Economic Commission for Europe**Inland Transport Committee****Working Party on the Transport of Dangerous Goods****Joint Meeting of the RID Committee of Experts and the
Working Party on the Transport of Dangerous Goods**

Bern, 14–18 March 2022

Tanks**Marking of tanks carrying flammable liquefied gases that are fitted with safety valves****Transmitted by Liquid Gas Europe on behalf of the BLEVE working group^{*}, ^{**}, ^{***}**

6.8.3.2.9.6.3

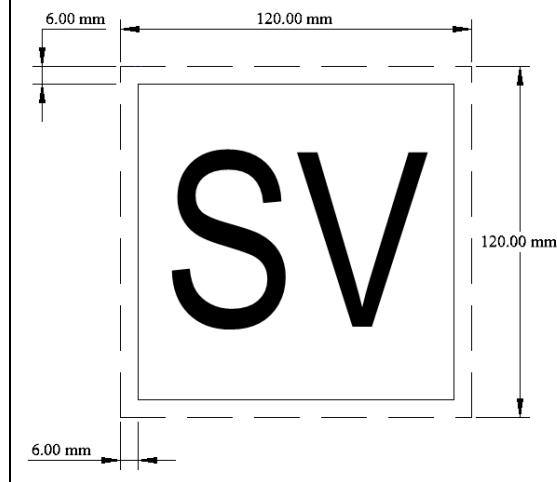
For tank-containers with a capacity of less than 1 500 litres the dimensions of the mark may be reduced to a minimum of 120 mm x 120 mm. The black line inside the edge shall be parallel and 6 mm from the outside of that line to the outside edge of the mark. The black letters ‘SV’ shall be a minimum of 60 mm high.
